RE: Broadstone Highlands Mid Block- Parking Lot & Ped. Bridge

Central and Cedar NE Grading and Drainage Plan

Hydrology File: K15D034D

Based on the submittal received on 12/6/19 the above-referenced Grading and Drainage Plan cannot be approved until the following are corrected:

DRAINAGE MANAGEMENT PLAN

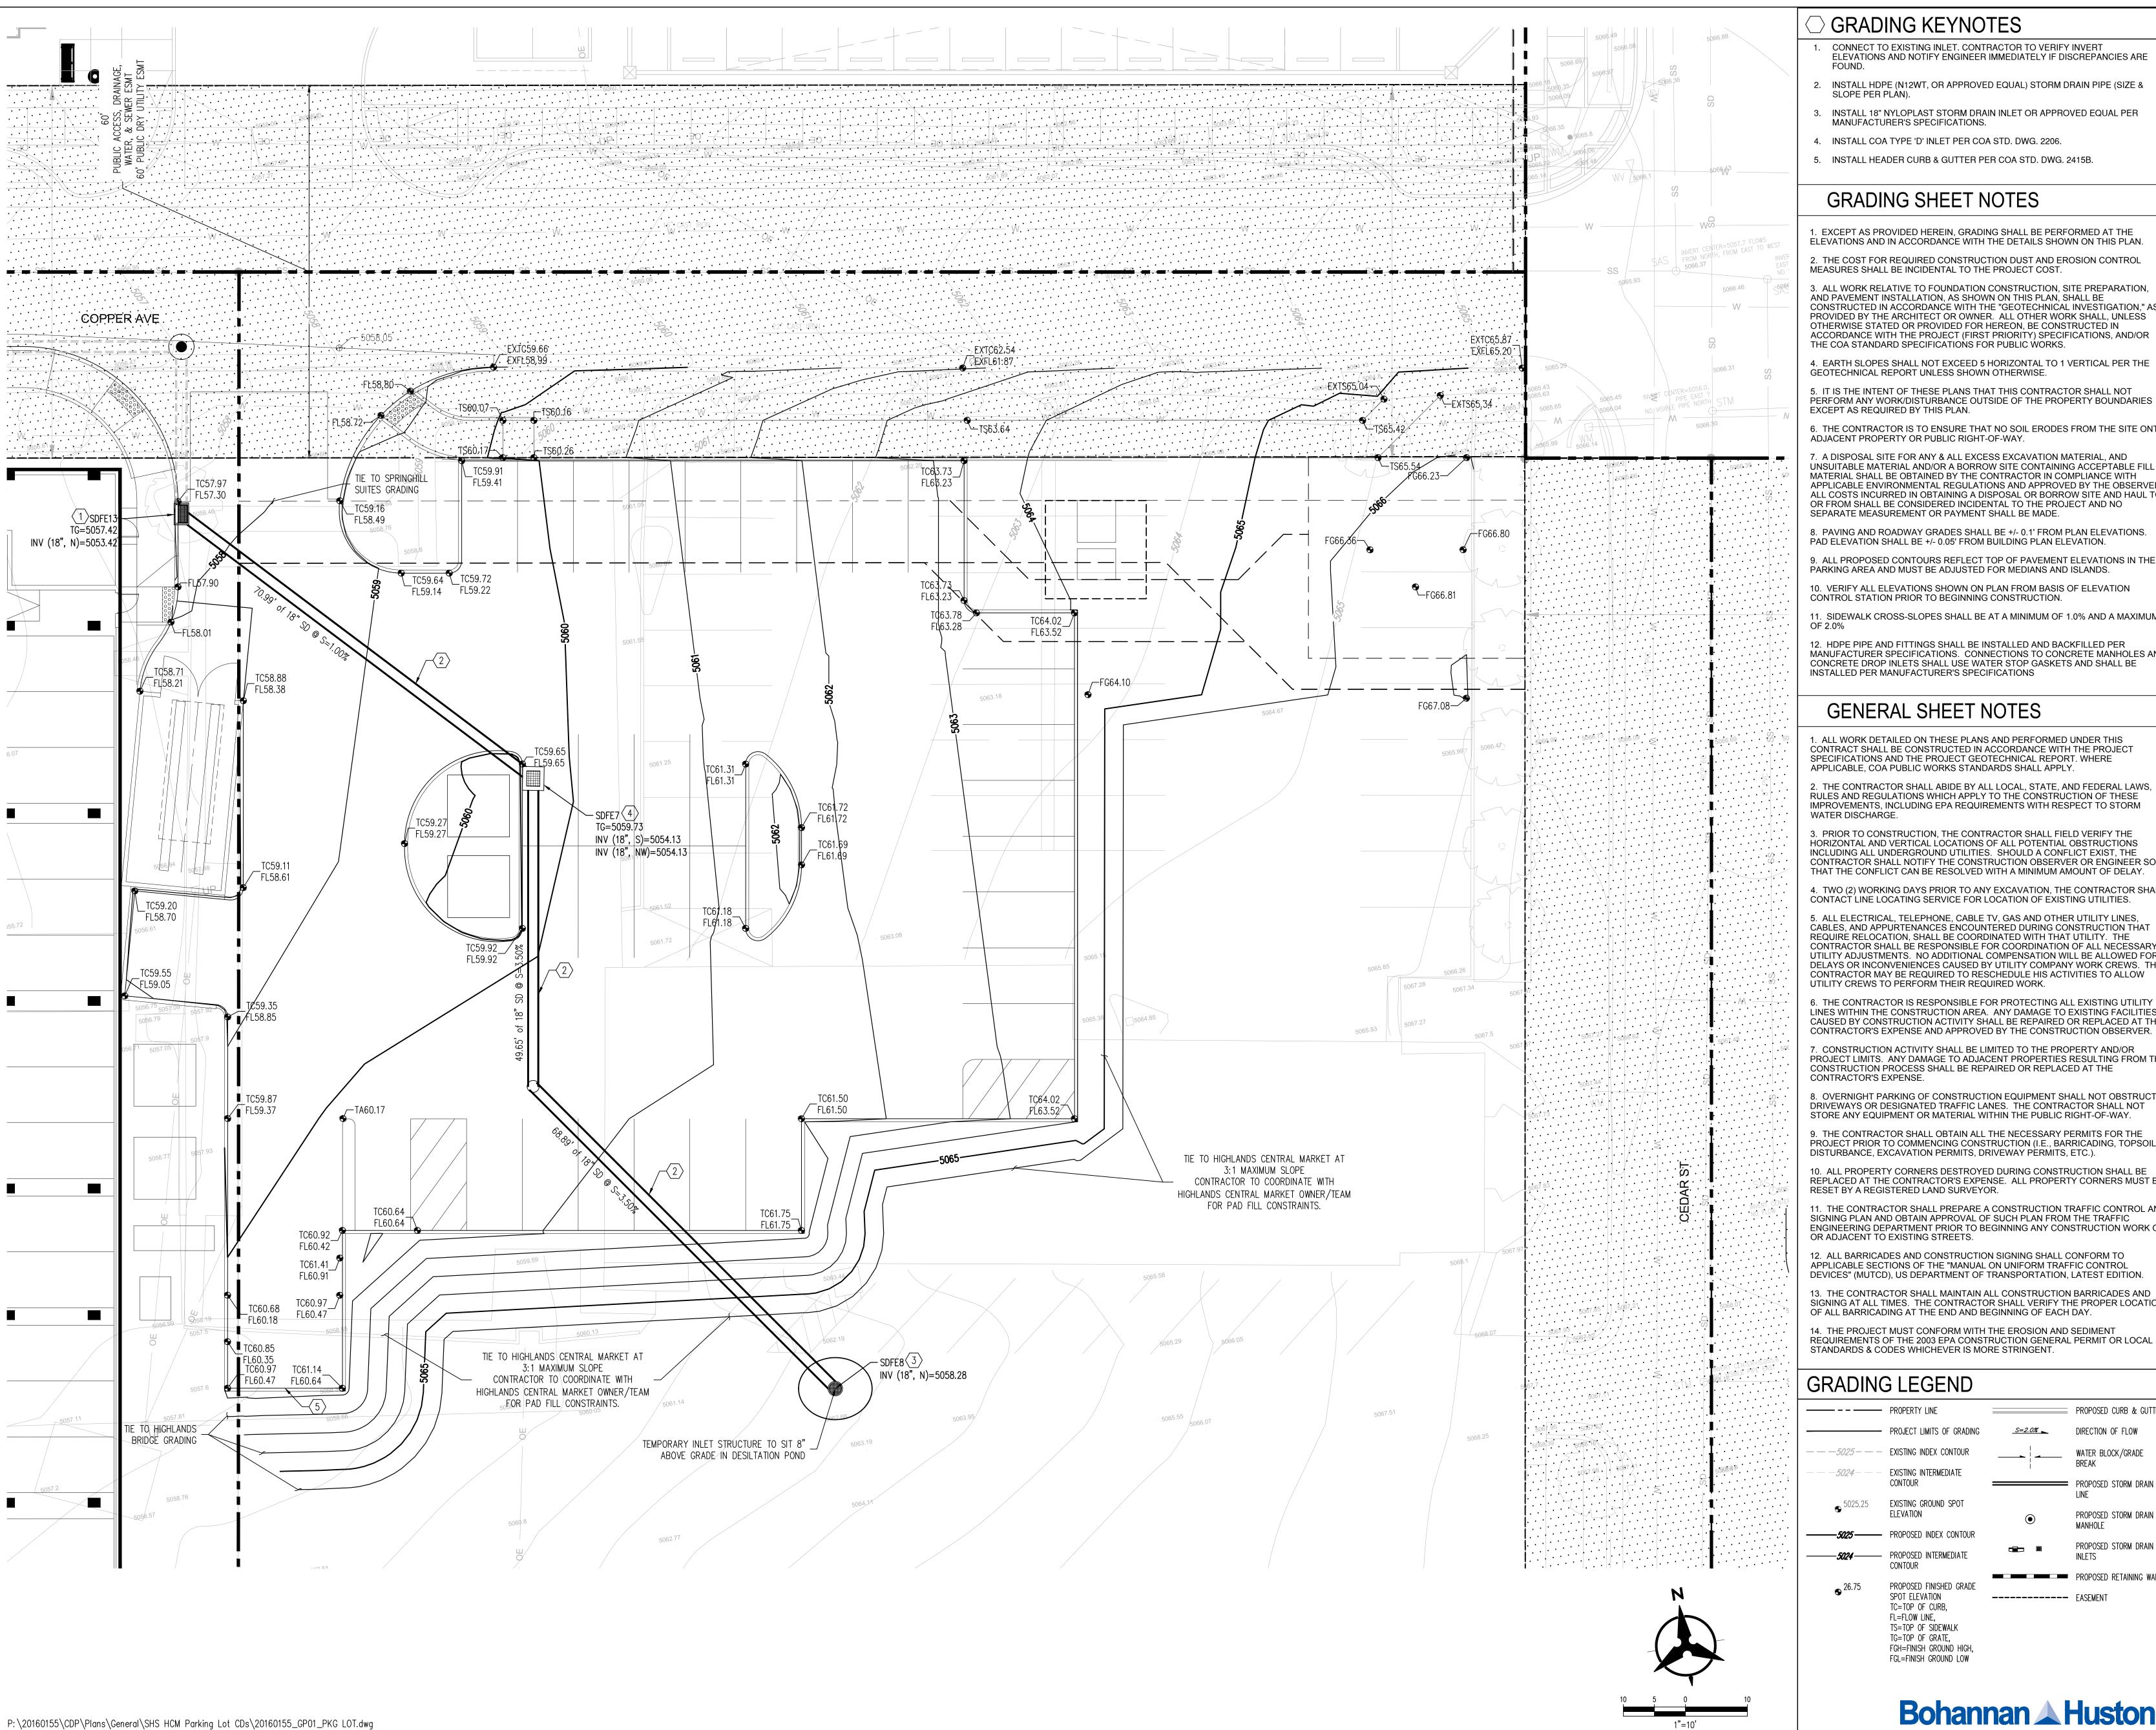
2. Payment in Lieu (Amount = 1983CF x \$8/CF = \$15864, per sheet C-001) of onsite management of the SWQV must be made. Take three copies of the treasury deposit slip to the Treasury and then include one copy of the paid deposit slip when resubmitting.
